Access Compliance Report Public Rights-of-Way (Curb Ramps)

Main Street: CHIRPING_SPARROW_WAY Cross Street: IRVINE_BLV Location: W

ADA ID: RPRK211014150633 Ramp Type: Type 4 - Parallel Initial Pass/Fail: Pass Overall Compliance: No Severity Score: 5

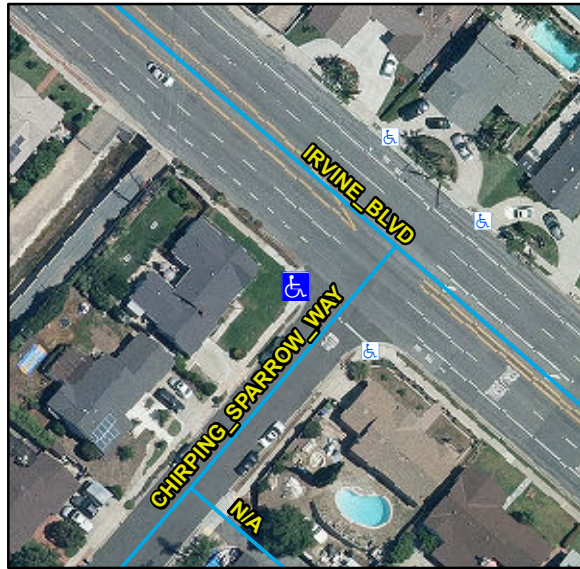
Crossing 1 Slope (%)	5		Crossing 2 Slope (%)	7.7
	Crossing 1 Cross Slope (%)	2		Crossing 2 Cross Slope (%)	1.6
Yes	Gutter Ponding	No	Yes	Curb Slope	3.6
Yes	Gutter Lip Height (in)	0		Road Run Slope (%)	0
No	Gutter Run Slope (%)	6.6		Road Cross Slope (%)	5.1
Yes	Gutter Cross Slope (%)	0.5	Yes	Perpendicular Joint Present	Yes
Yes	Overall Surface Condition	Acceptable			
	Cross Gutter Present?	No		Spandrel Present?	No
	Replace Cross Gutter?	N/A		Replace Spandrel?	N/A

Possible Solutions:

Remove & Replace Gutter.

R304.5.4, STD 1115
